July 8, 2024

Re:*Response to Staff Comments
NOI Filing (DEP File No. 239-0980)– Albemarle Park Improvement Project
250 Albemarle Road in Newton, Massachusetts*

Staff comments were received on June 28, 2024, for the Albemarle Park Improvement Project, located at 250 Albemarle Road in Newton, Massachusetts. Each comment is outlined below, with a response in **bold text**.

ATTACHMENT 1

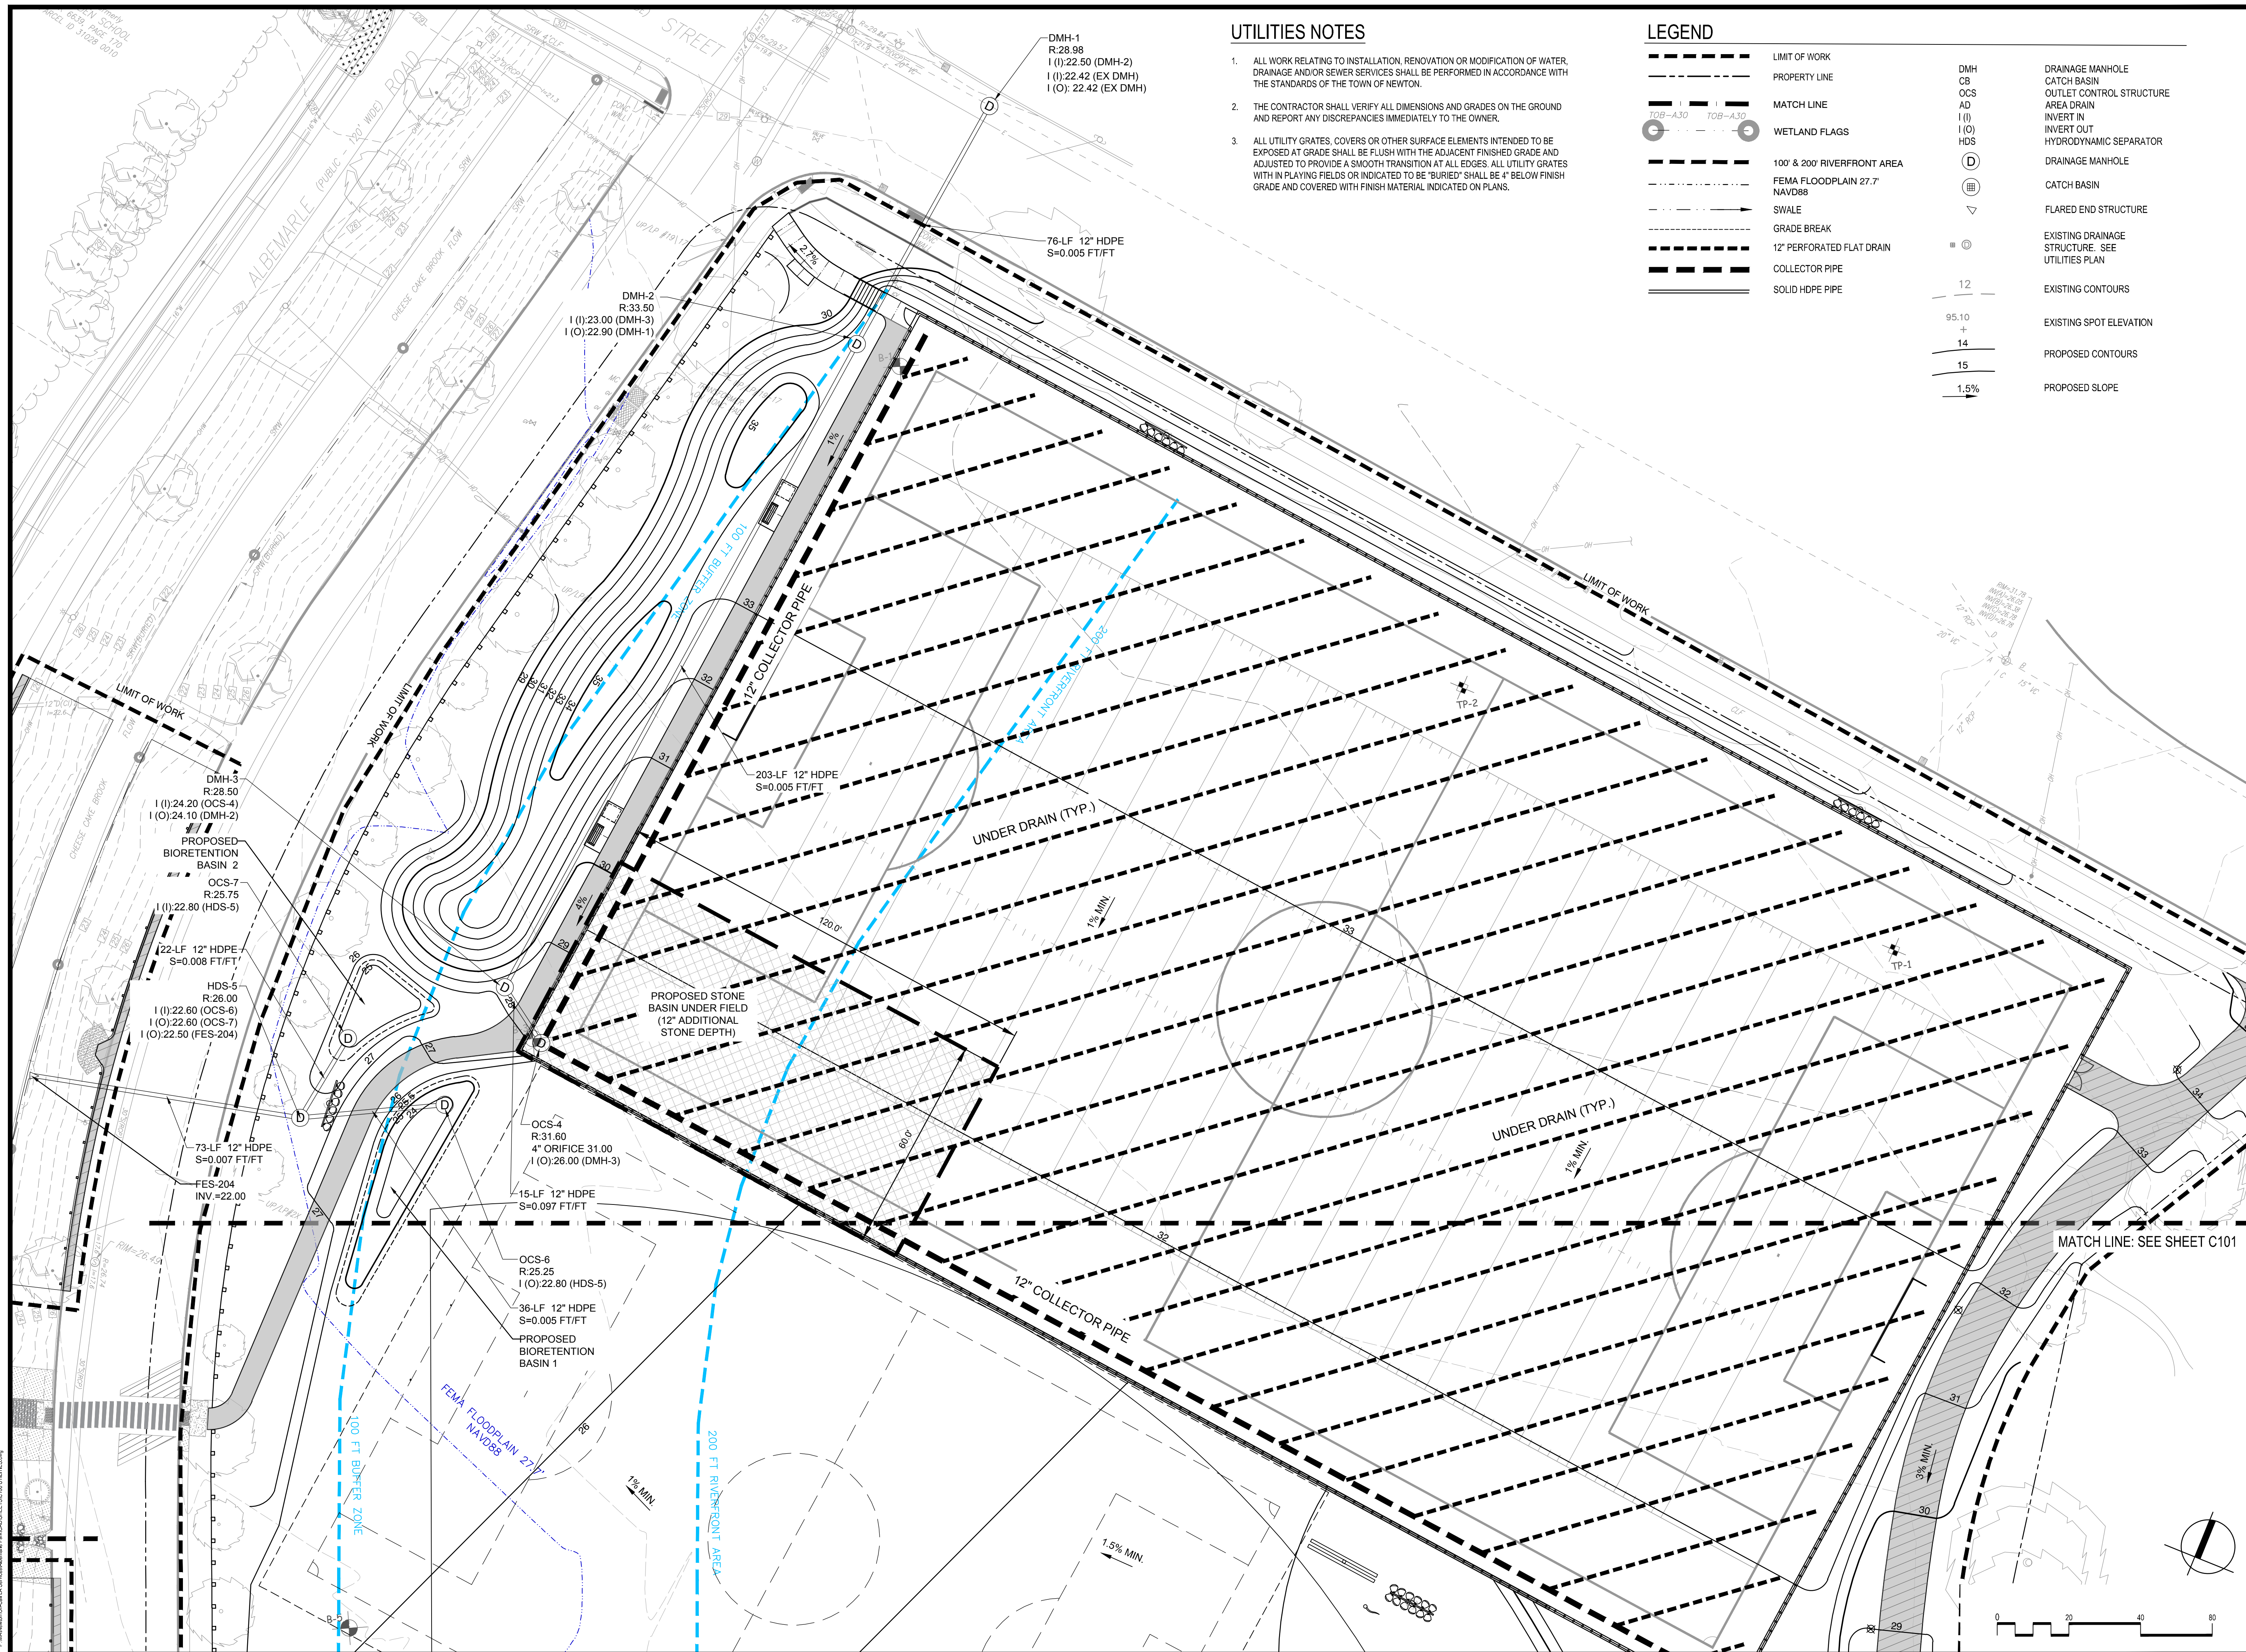
Staff would like to see a plan sheet that illustrates existing and proposed grades, with shading where cuts and fills will occur, and the location of the proposed floodplain contour.

W&S Response: A plan sheet with shading where cuts and fills are taking place is located as Attachment 1 to this letter.
